HAM-VINE STREET NS

General Comment:

Given the geometric issues discussed on 9/4/24, between ORDC, D8, M&H, and Woolpert, the Stage 2 plans will need to be re-submitted showing the revised roadway design, accommodating the proposed truck turning arrangements, proposed by Woolpert.

TITLE SHEET

DESIGNER: TK
 REVIEWER: SJS
 PROJECT ID: 96425
 SHEET: P.23 TOTAL: 35

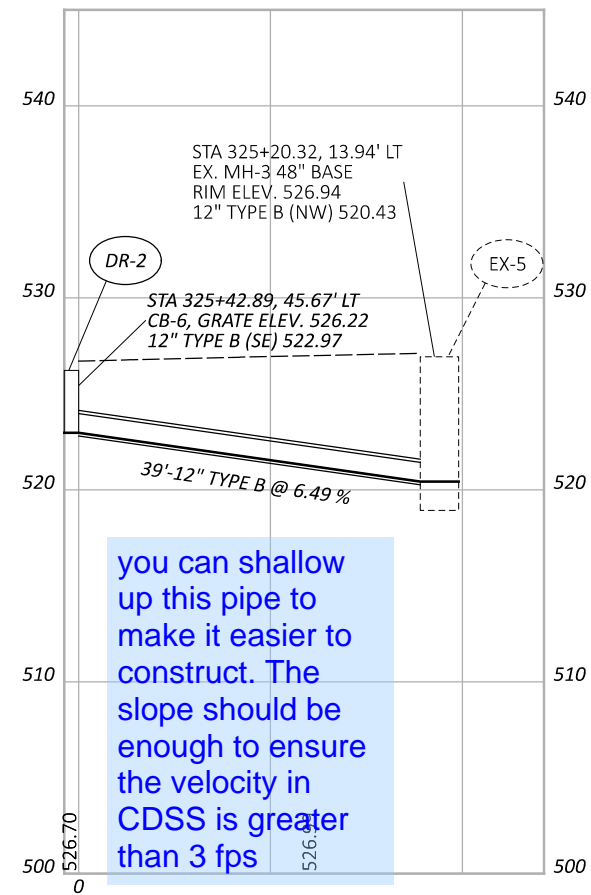
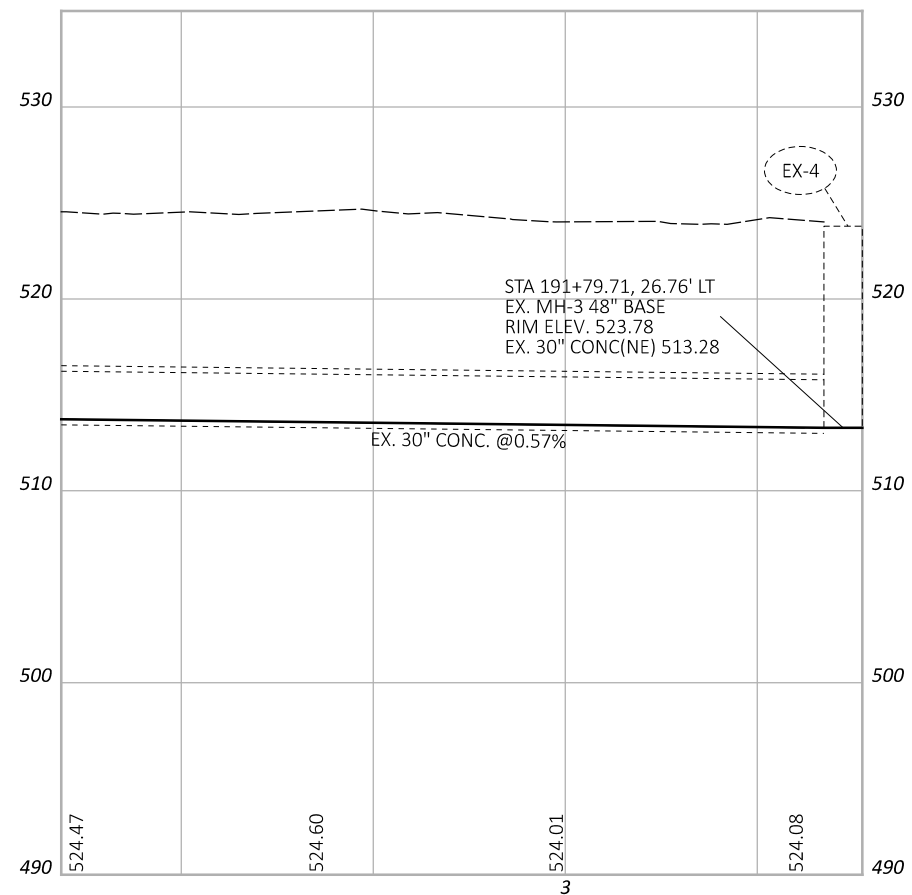
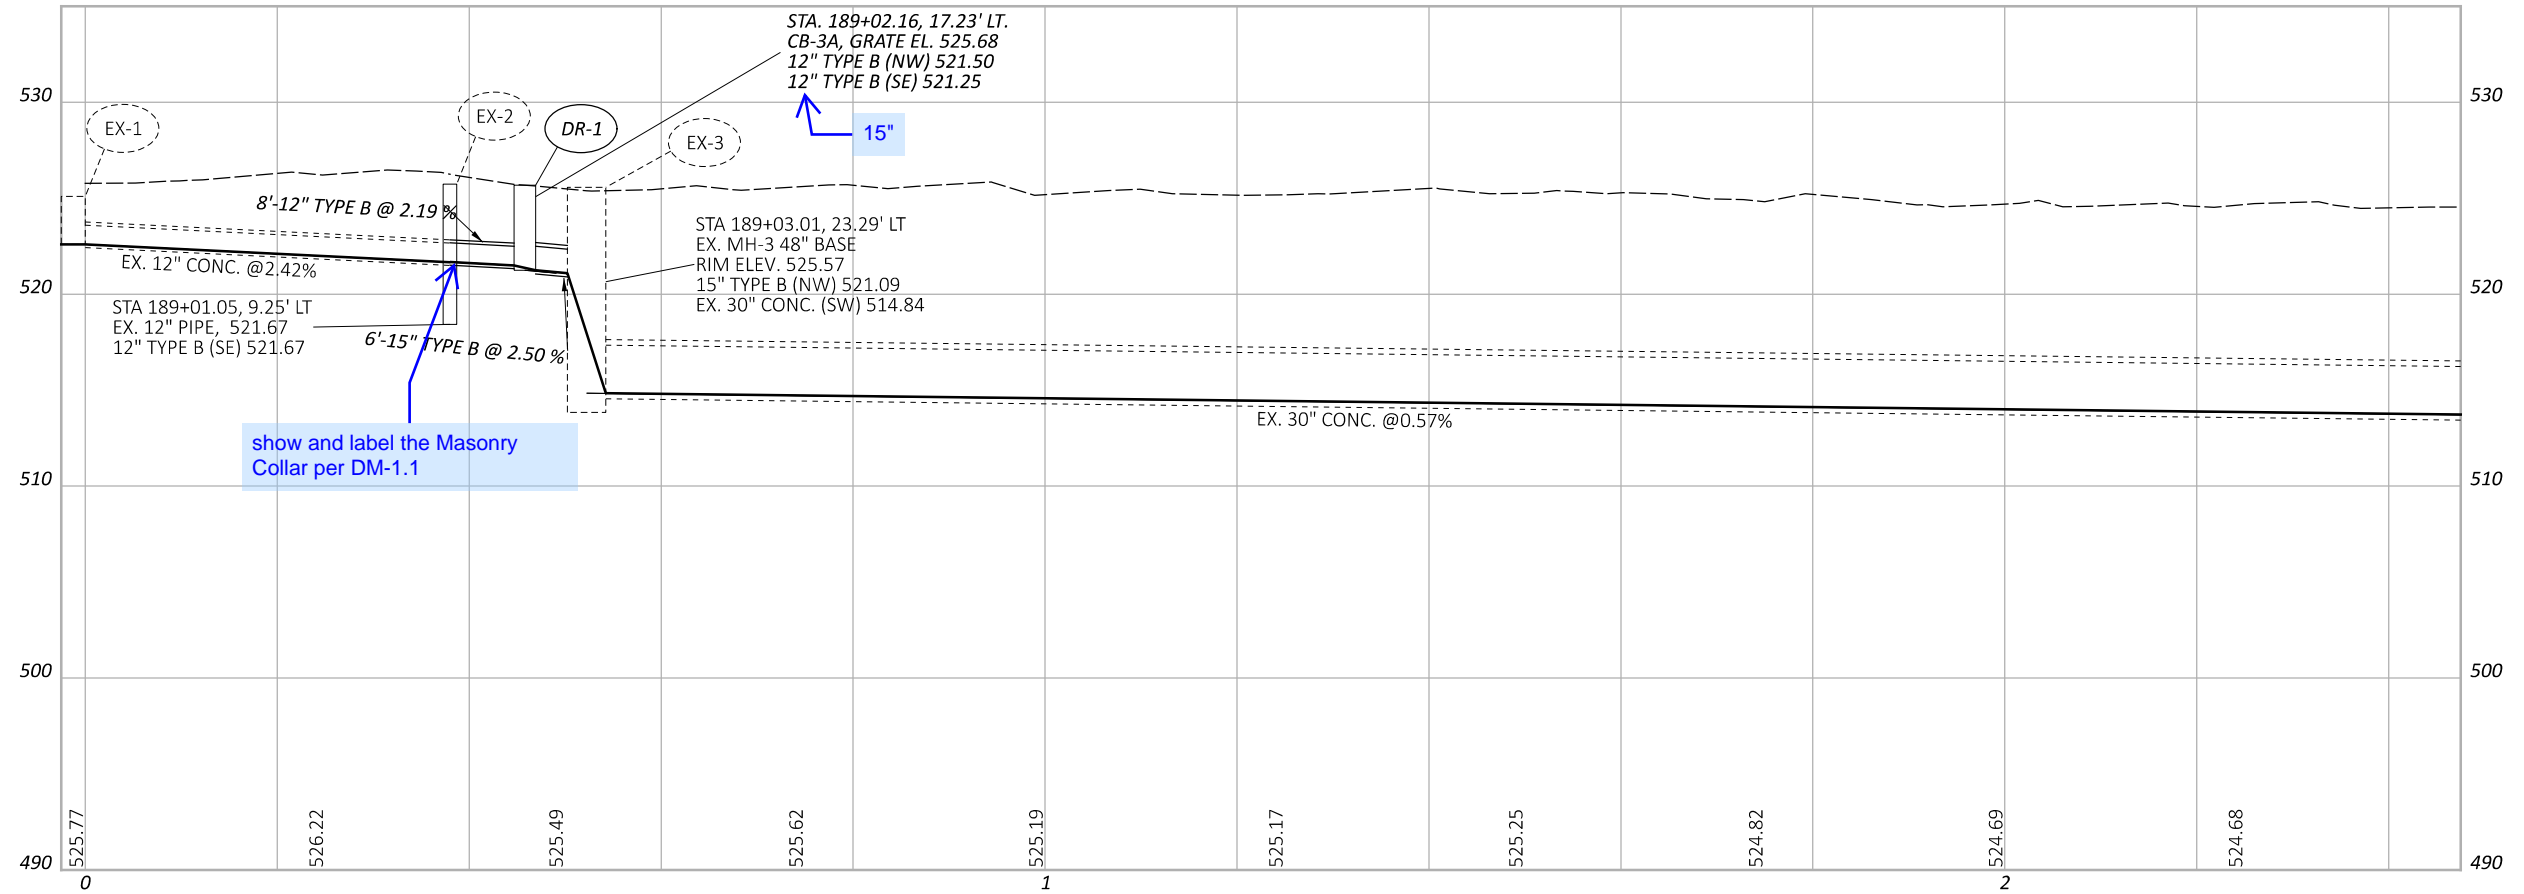
Label lane widths and transitions

Show proposed R/W lines

Extend channelizing line beyond ONLY markings. Place additional left arrows per SCD. Revise lane line to be wide dotted line for mandatory left turn lane, with LEFT LANE MUST TURN LEFT sign. May need to extend striping limits

extend channelizing lines and add chevrons, remove dotted line

Recommend removing thru arrow and ONLY marking

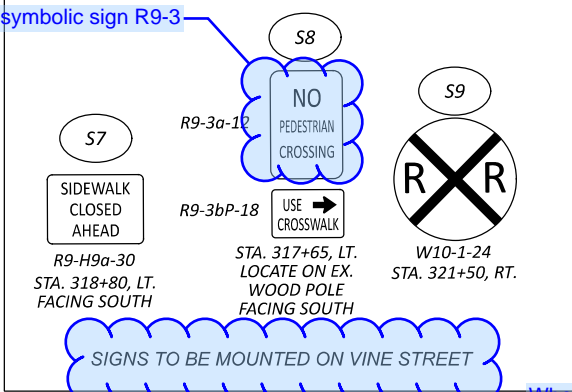
The right turn lane is too wide. Add a painted island with chevrons

Use symbolic sign R9-3

Where on Vine St? Show on plans

VINE STREET & SPRING GROVE AVENUE
SIGNING & PAVEMENT MARKING PLAN
STA. 189+50 TO END

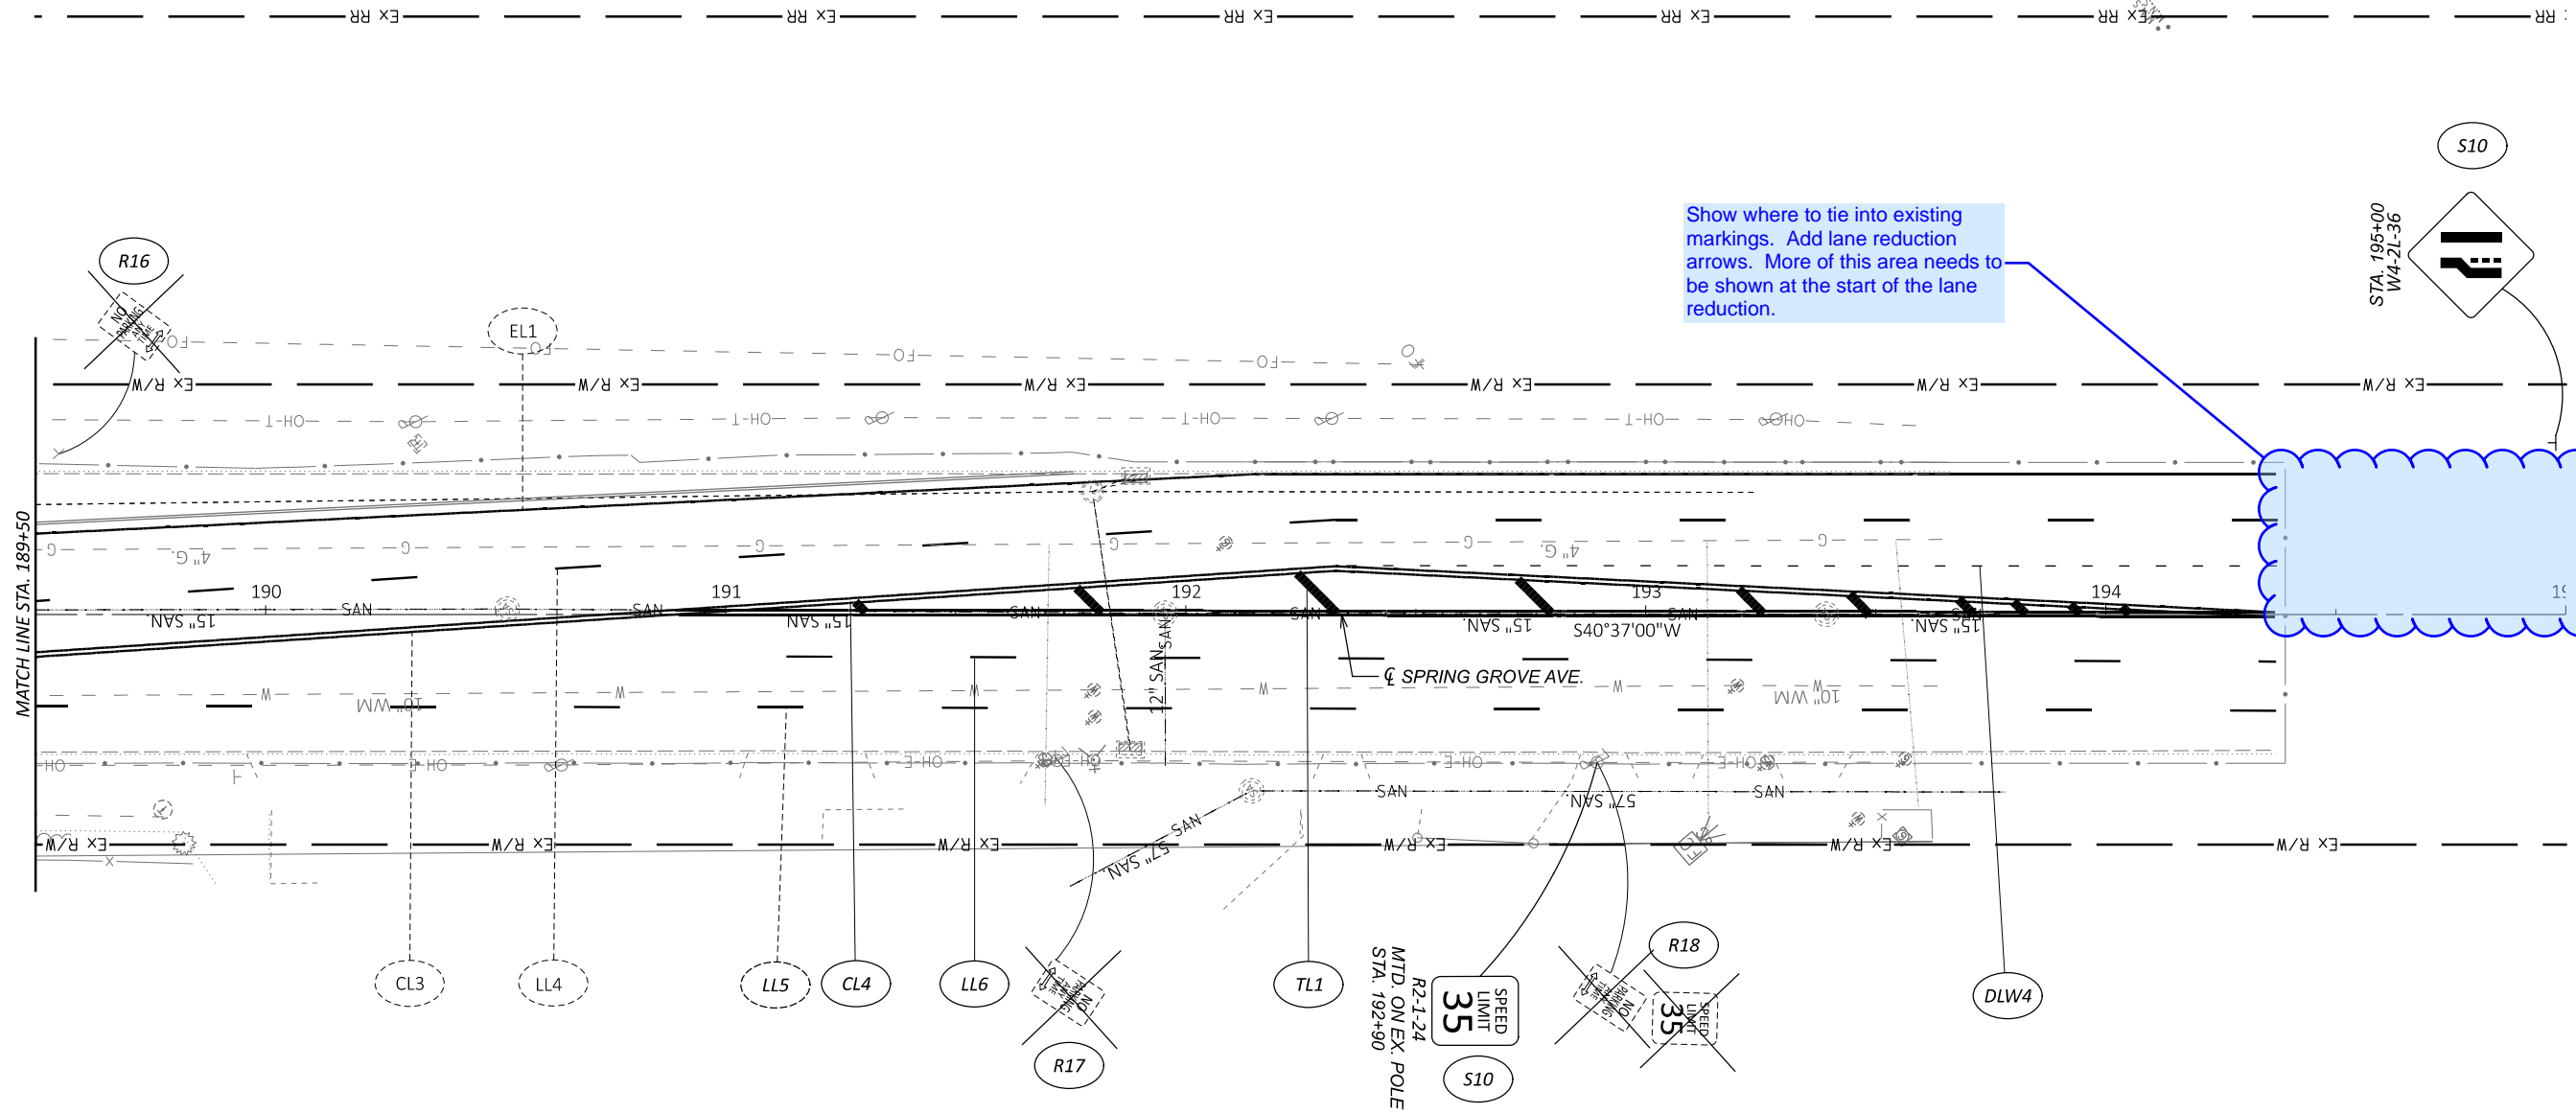
Show where to tie into existing markings. Add lane reduction arrows. More of this area needs to be shown at the start of the lane reduction.

**VINE STREET & SPRING GROVE AVENUE
SIGNAL REMOVAL PLAN**

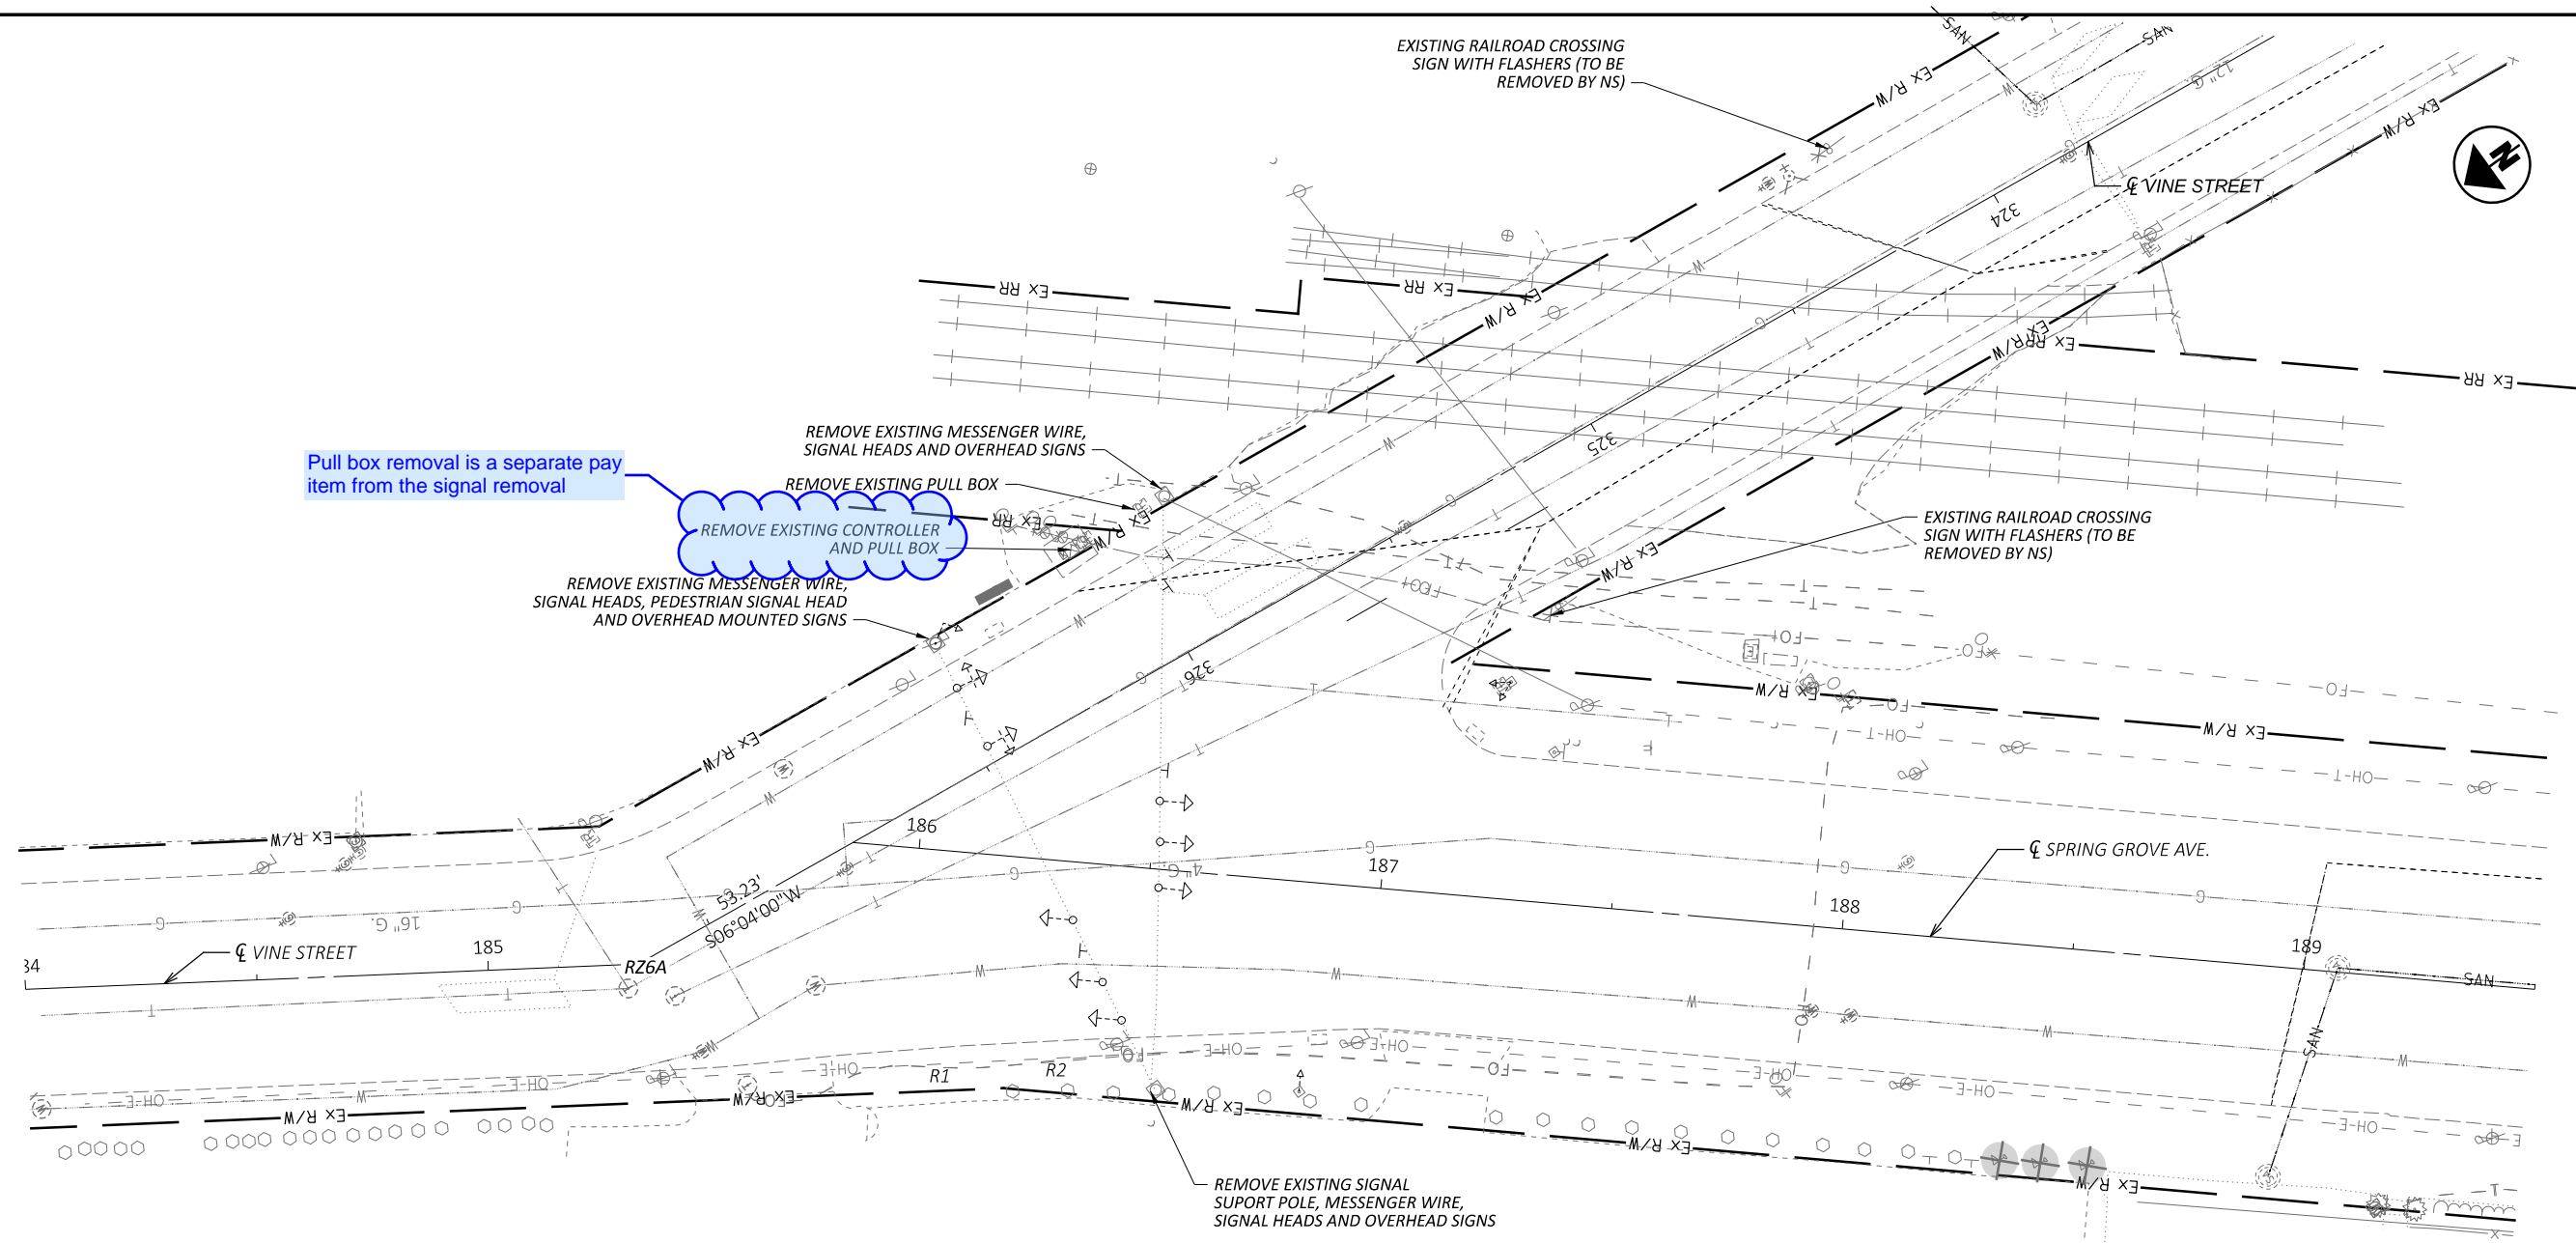
Pull box removal is a separate pay item from the signal removal
